# ADVANCED NUCLEAR FUELS CORPORATION

XN-NF-87-24  
Issue Date: 3/26/87

## WNP-2 CYCLE 3 PLANT TRANSIENT ANALYSIS

EXAMPLE

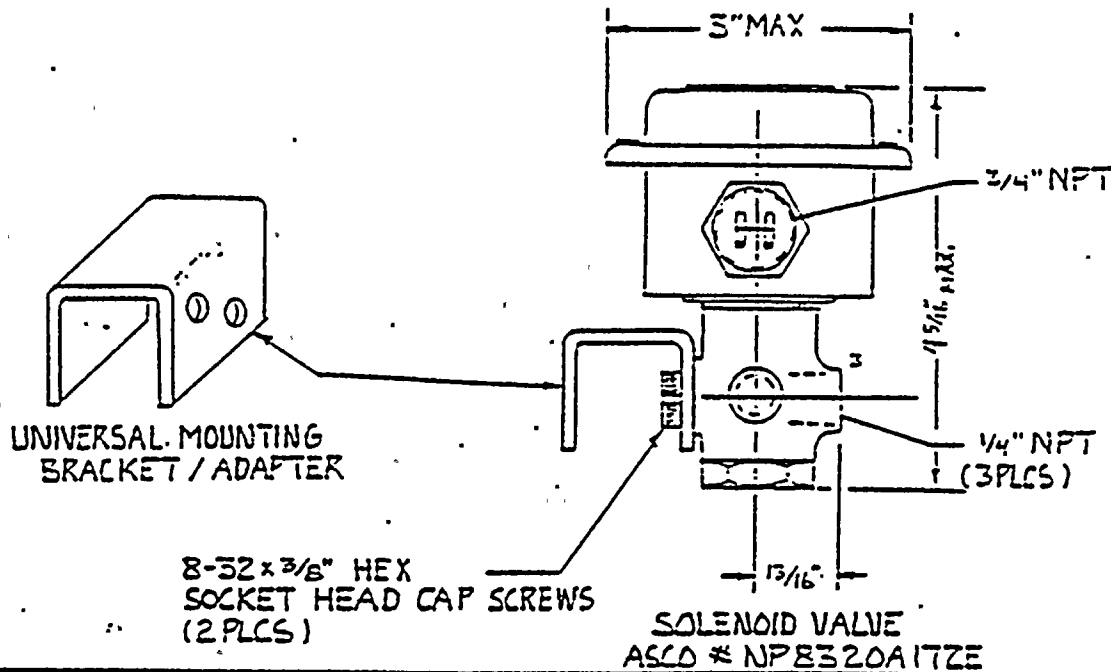
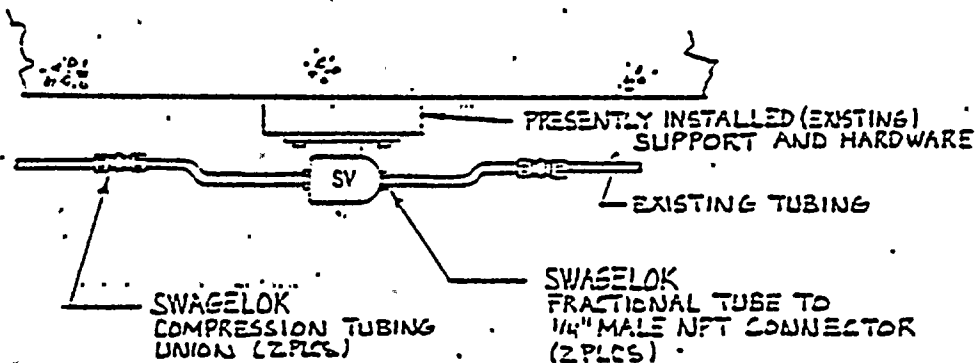
REMOVE SOLENOID VALVES ROA-SPV-10,11,12,13,14,15 & 17 (ASCO MODEL NO. HXB8320A1 & B1) AND REPLACE WITH NUCLEAR QUALIFIED UNITS (ASCO MODEL NO. NP8320A1TZE), AS FOLLOWS.

1. REMOVE EXISTING SOLENOID VALVES (ASCO HXB8320A1 & B1) AND RETURN TO WAREHOUSE AS SPARES. RETAIN HARDWARE FOR LATER USE.
2. FABRICATE SEVEN (7) "UNIVERSAL MOUNTING BRACKET / ADAPTERS, AS SHOWN ON PAGE 006 OF THIS DCP.  
NOTE: DRILL MOUNTING HOLES IN L-SIDE OF BRACKETS TO MATCH EXISTING SUPPORT / HANGER HOLE CONFIGURATION FOR THE INDIVIDUAL SOLENOID VALVE INSTALLATIONS.

NOTE: PRESENTLY INSTALLED SUPPORT AND HARDWARE CONFIGURATION MAY VARY FROM INSTALLATION TO INSTALLATION.

NOTE: REFER TO PAGE 006 OF THIS DCP FOR UNIVERSAL MOUNTING BRACKET FABRICATION.
